STAFF MEMORANDUM

Subject: **Case SP #2022-03 Amherst Label Realty, LLC, Tax Map 15, Lot 15, 15 Westchester Drive**
Public Hearing for a Major Site Plan to construct a 13,305 square foot building addition, stormwater management design, and related site and landscaping improvements within the Industrial zoning district.

**Re: Amherst Label Expansion (Tax Map 15, Lot 15)
Site Plan Drainage Review**

Response Letter #1

SP-3
 SHEET

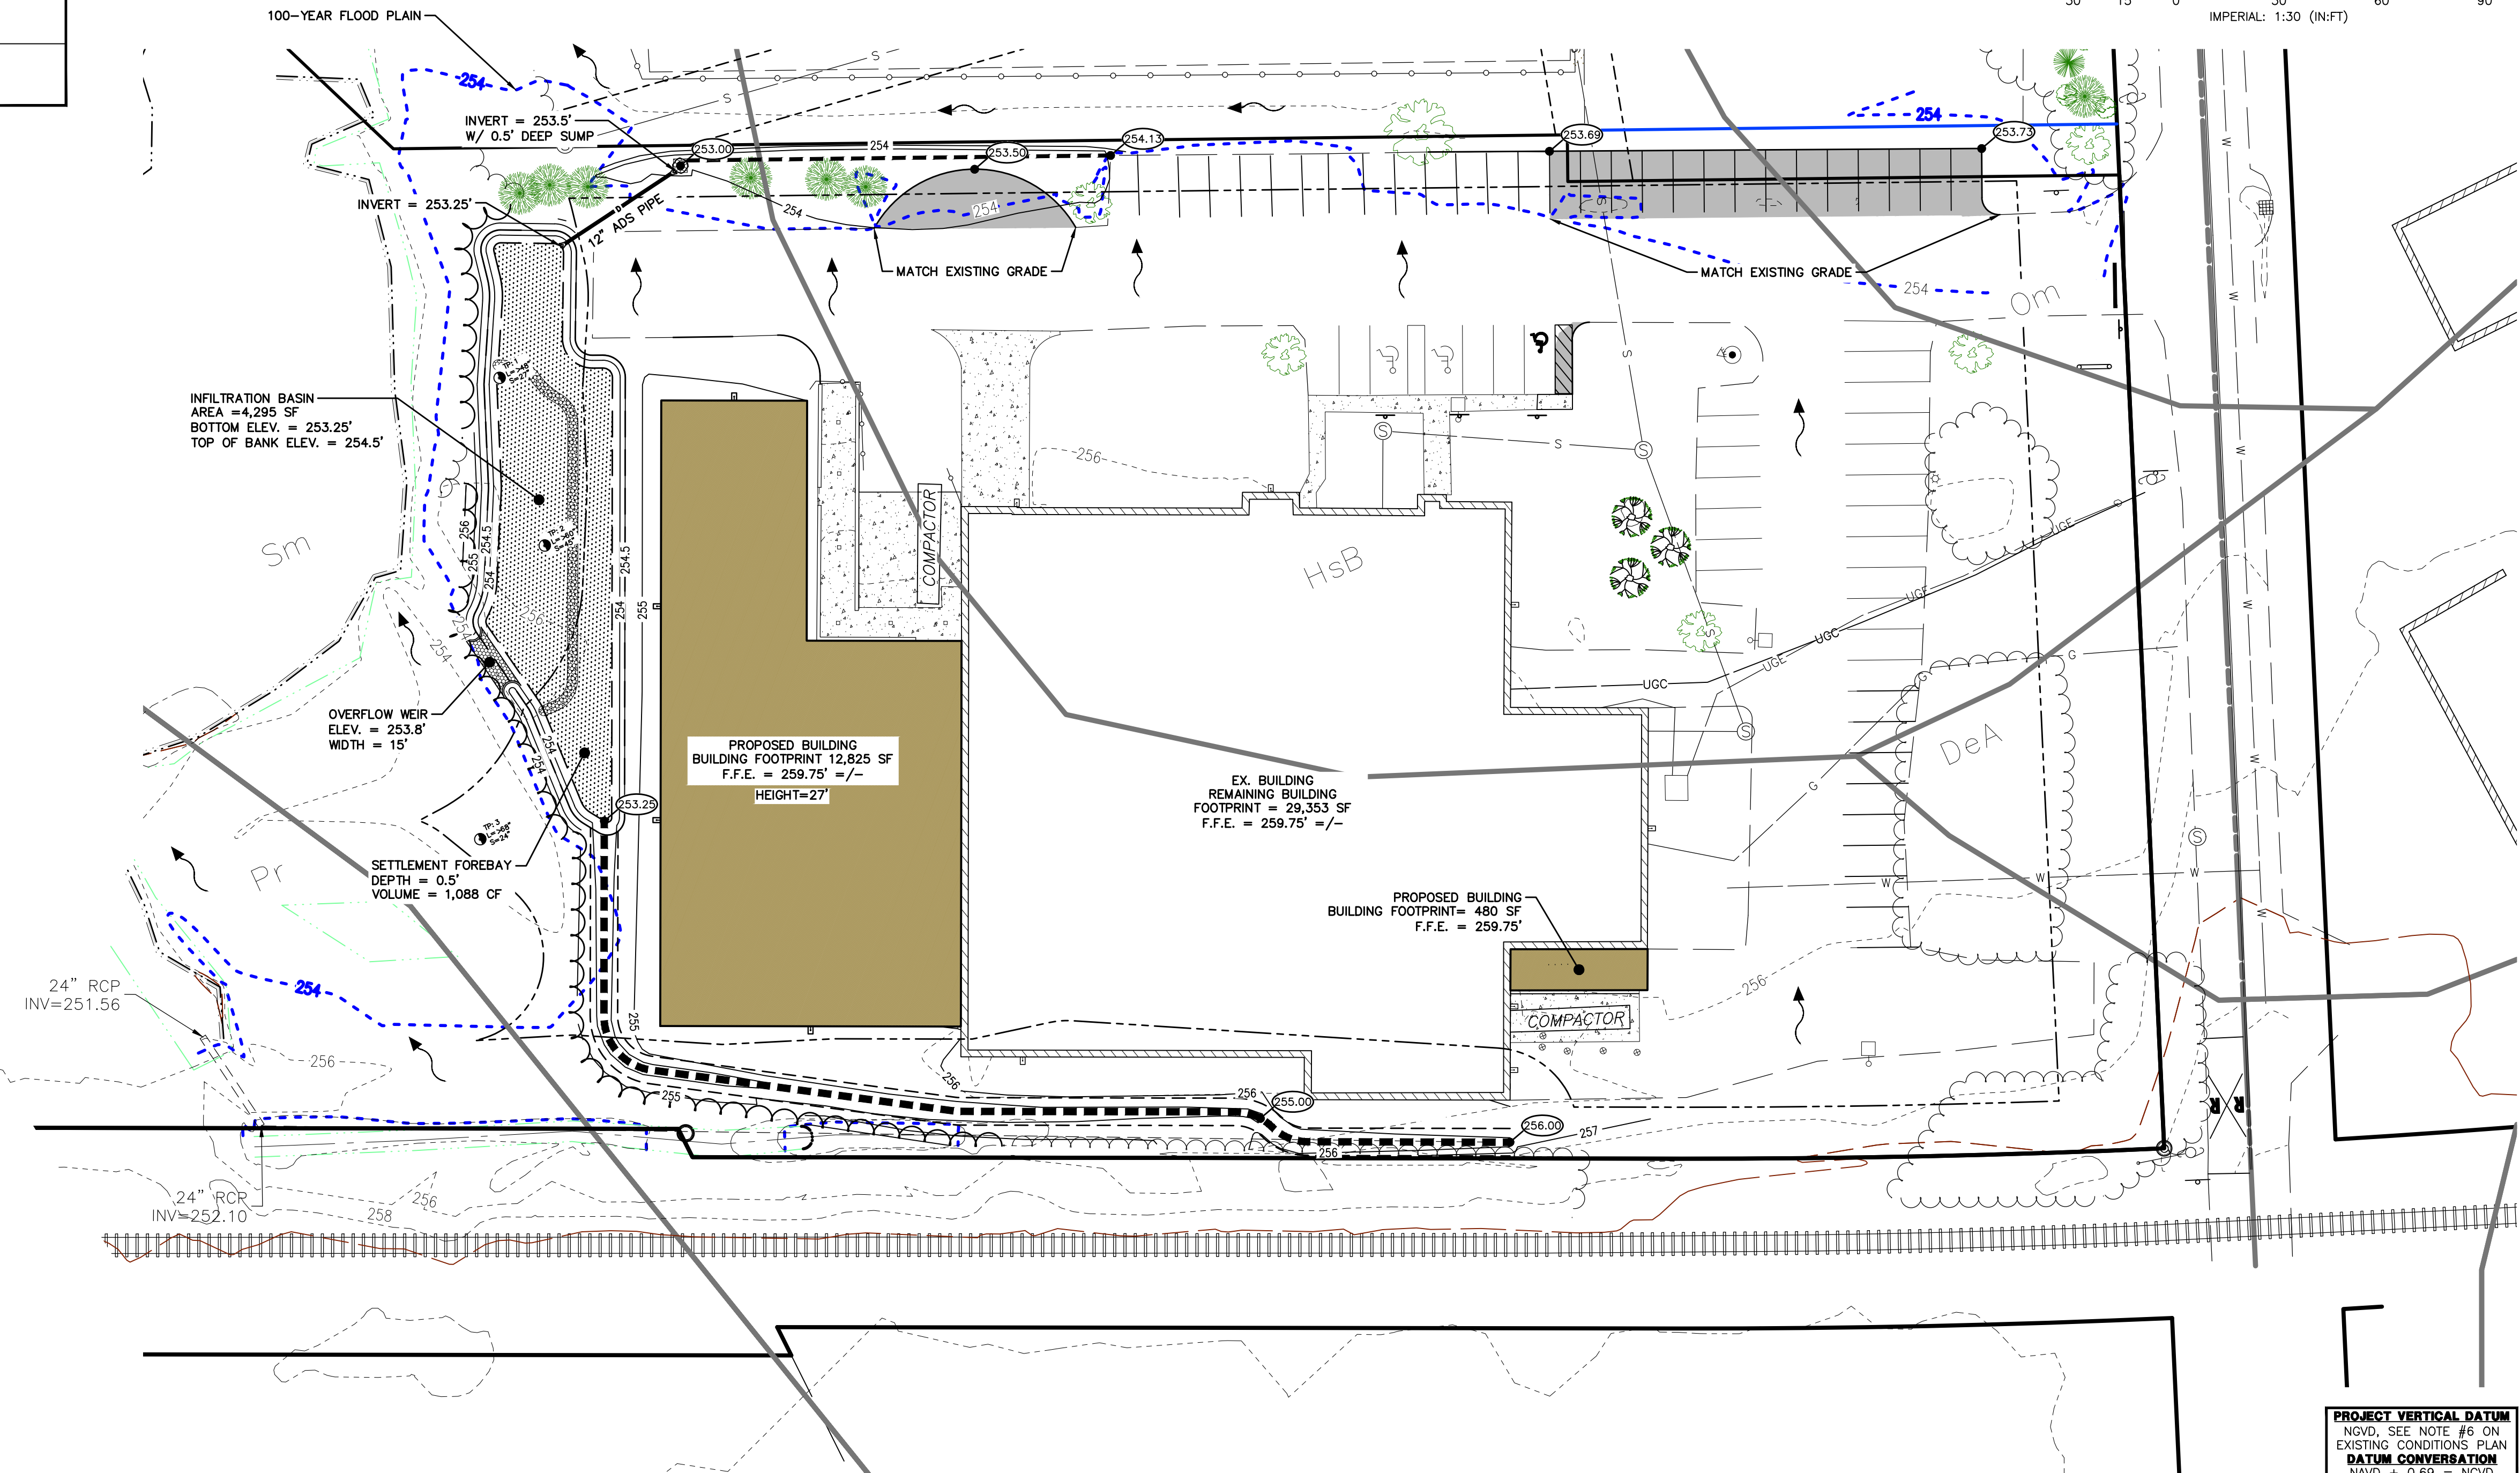
20. Question – Site Plan, Sheet 5 (SP-3). The sheet displays stormwater runoff sheet flowing to the swale between the subject property and the abutting Map 15, Lot 15-1. It is staff's understanding that the swale is directly connected / flows into the wetland resource area and eventually into Tucker Brook. Please explain what measures are taken to pre-treat the stormwater prior to discharge.

21. Question – Site Plan, Sheet 5 (SP-3). Please detail the snow plowing and removal protocols and efforts to reduce sodium chloride use.

Staffs understanding of this swale is correct, it does collect runoff from the site and convey it to the wetlands. The best attempt has been made to capture the most stormwater runoff as possible and convey it to the infiltration basin. This was done with a berm/swale to collect the runoff and convey it to a drainage pipe that connects it to the basin.

A note has been added to the general development notes stating "Snow to be stored in areas delineated on the plan. during the periods of time of excess snow fall, snow is to be moved off site to appropriate facilities following appropriate methods." See note 17 of the General Development Notes on sheet 4.

AMHERST LABEL EXPANSION
LANDSCAPING PLAN
MARCH 10, 2022

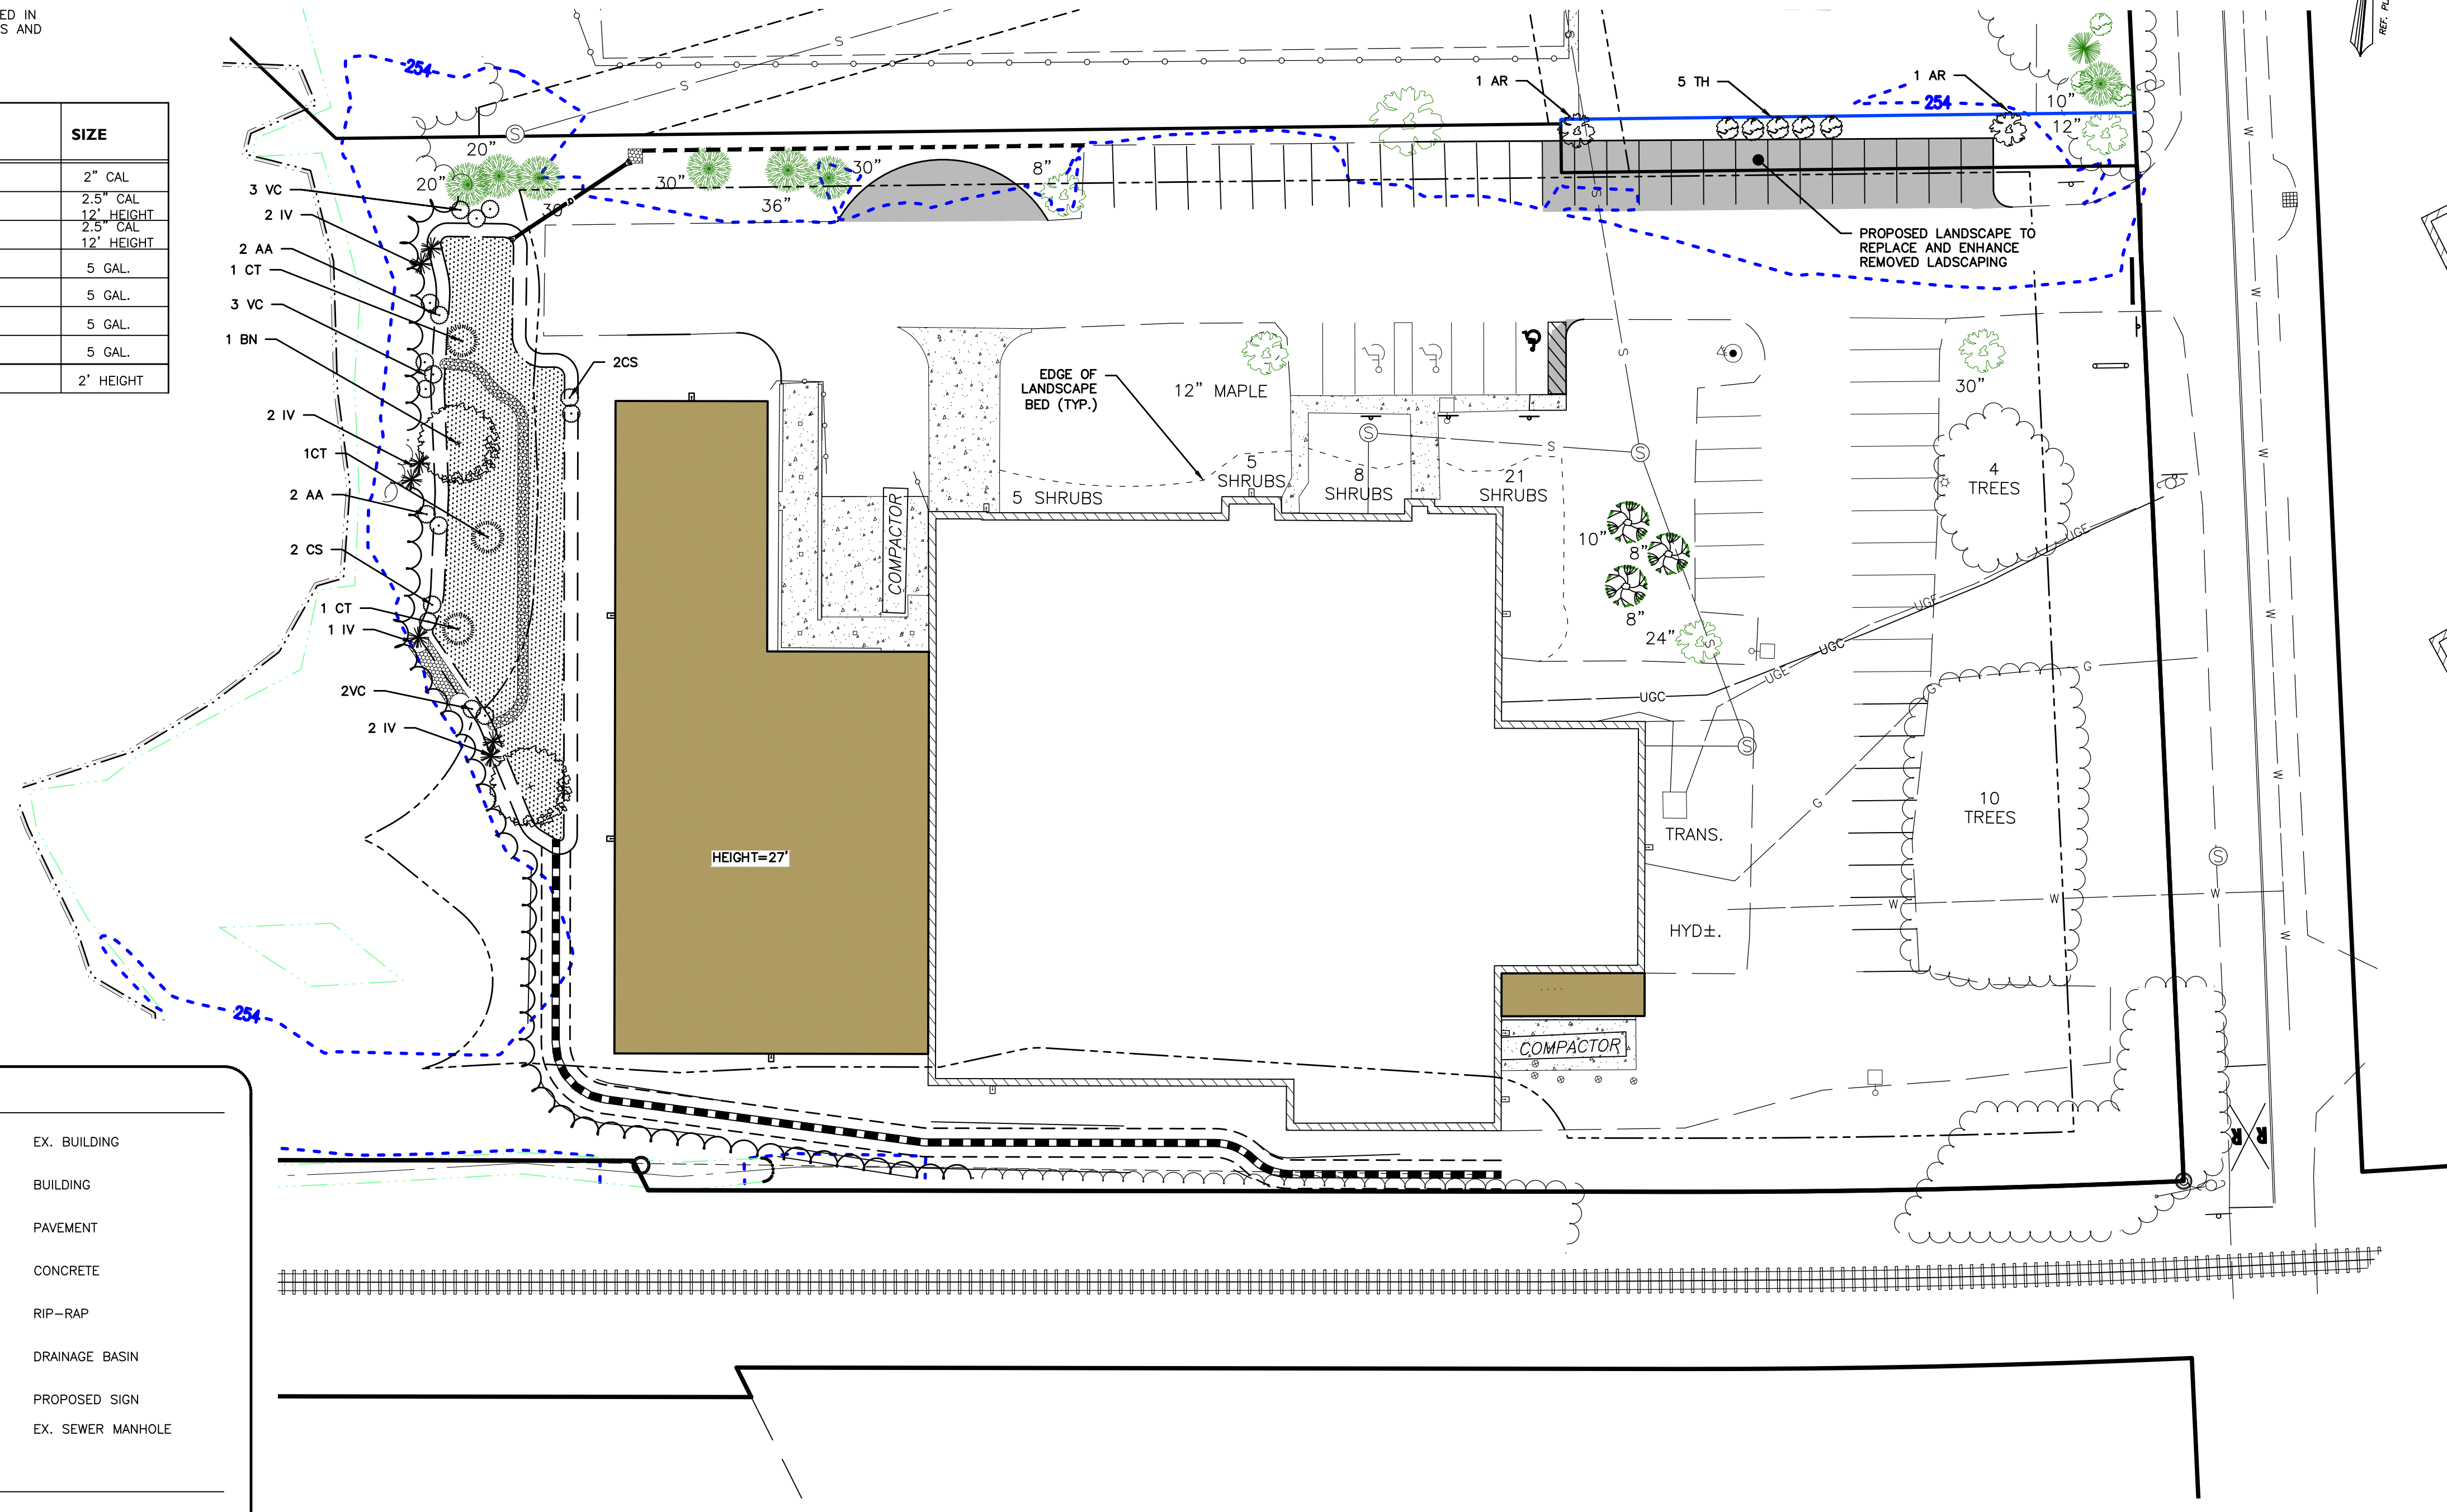
22. Question – Site Plan, Sheet 6 (LS-1). The plan shows new parking spaces located along the northeast portion of the developed lot (shaded in gray). Please explain what if any landscaping improvements are being proposed. Staff recommends plantings with what appears to be a proposed green strip between the two properties to provide pre-treatment of the stormwater runoff, to delineate the property boundaries, and provide visual mitigation.

23. Question – Site Plan, Sheet 6 (LS-1). Please update the planting table for the River Birch and Atlantic White Cedar to state 2.5” caliper and 12 feet in height pursuant to Section 6.08.8 of the Development Regulations.

As discussed with Lincoln Daley via telephone on May 11, 2022, this area should be landscaped to visually break up the two properties. The landscaping has been added to replace the removed tree and shrubs. The buffer is enhanced by removing a strip of asphalt creating a green space and by adding a n additional tree where it was possible to do so. See sheet 6.

The sizes of the River Birch and Atlantic White Cedar has been revised to be 2.5” caliper and 12 feet in height. See sheet 6.
